Factory and fabrication cut-off

CLIO II

19 ECHOING UNDER BODY AT FRONT LEFT-HAND SIDE OF VEHICLE.

Fig. 1

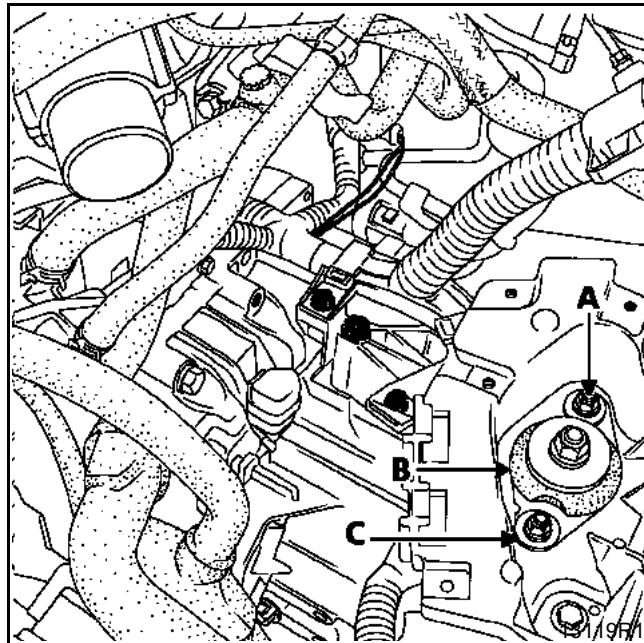
- Echoing under body at front left-hand of vehicle when driving.

- Gearbox elastic support mountings.

- Replace the two nuts and washers on the gearbox elastic support mounting.

- 2 nuts **Part no.: 77 03 034 124**
- 2 washers **Part no.: 77 03 053 537**

#### Description of the operation:
